February 11, 2008
357891

RE: Data Response, Set 1B
Ivanpah Solar Electric Generating System (07-AFC-5)

Ivanpah Solar Electric Generating System (ISEGS)

Data Response, Set 1B

FIGURE DR40-2
ALLUVIAL FAN SURFACES
IDENTIFIED BY THEIR LOW ALBEDO
IVANPAH SOLAR ELECTRIC GENERATING SYSTEM

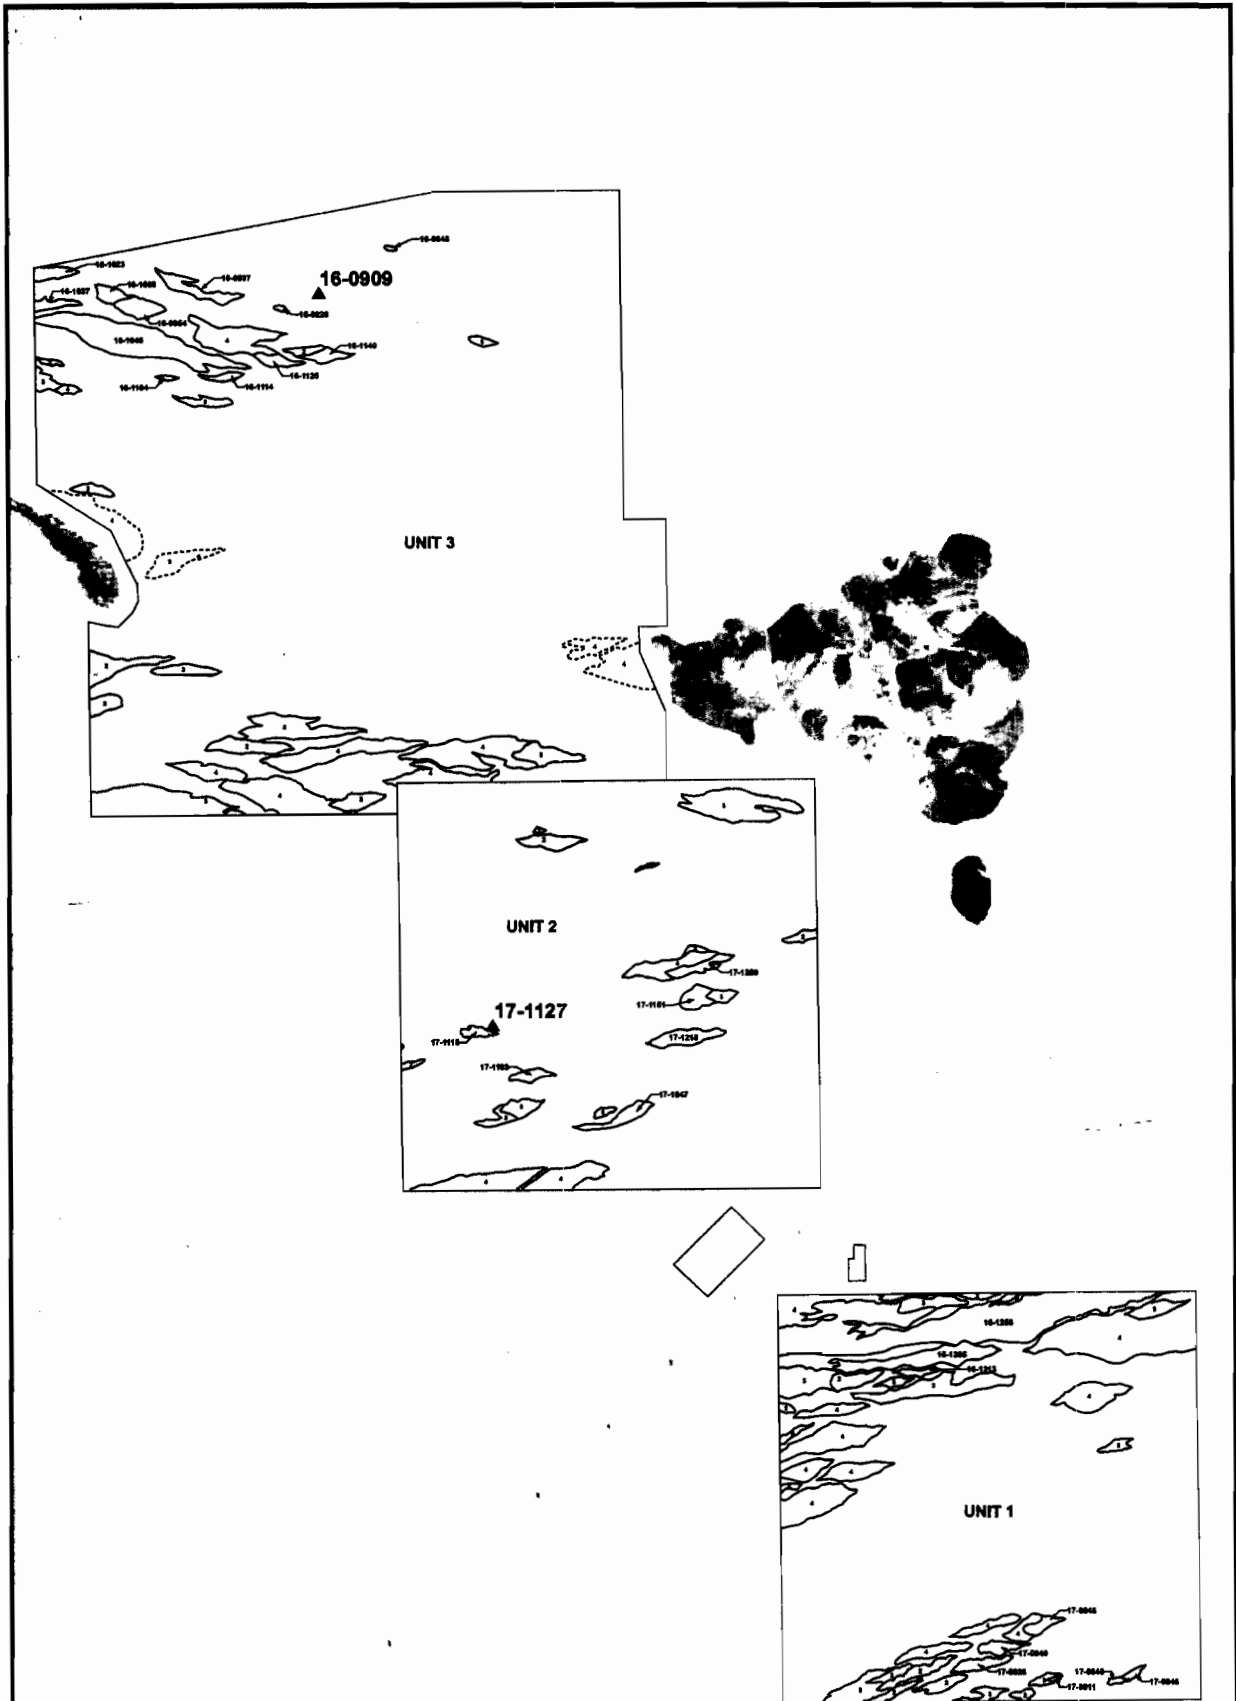
40. Please provide a discussion of the historical geomorphology of the project site to better evidence a consideration of the potential there for buried archaeological deposits. The discussion should describe the development of the bajada on which the project area is proposed with a focus on the character of the bajada's depositional regime since the Late Pleistocene era. The basis for the discussion should be data on the geomorphology, sedimentology, pedology, and stratigraphy of the project area or the near vicinity. The source of these data may be a combination, as necessary, of extant literature or primary field research.

Examination of a high resolution aerial photograph of the project area reveals surface morphology expected from a bajada dominated by alluvial fans undergoing widespread erosion (Figure DR40-2). The surface is covered with wide networks of braided or anastomosing channels, and the interfluvies between the channels appear generally young with soils that are poorly developed if not altogether absent. Alluvial fan dissection such as that taking place currently is often attributed to a reduction of new sediment carried to the fan by floods and debris flows issuing from canyon mouths (e.g., Harvey and Wells, 2003). The switch from a progradational to an erosional style by the fans of the Clark Mountain bajada may, therefore, be linked to increased vegetation cover and reduced sediment yield associated with generally increased effective moisture during the late Holocene (Spaulding 1990; Koehler, Anderson, and Spaulding, 2004). This effect (increased effective moisture promoting increased vegetation cover resulting in enhanced slope stability; see Bull [1991]) would have been most pronounced at higher elevations where dense scrub and woodland occur, and all source areas for the alluvium on the fans of the Clark Mountain bajada lie above 4,000 feet amsl.
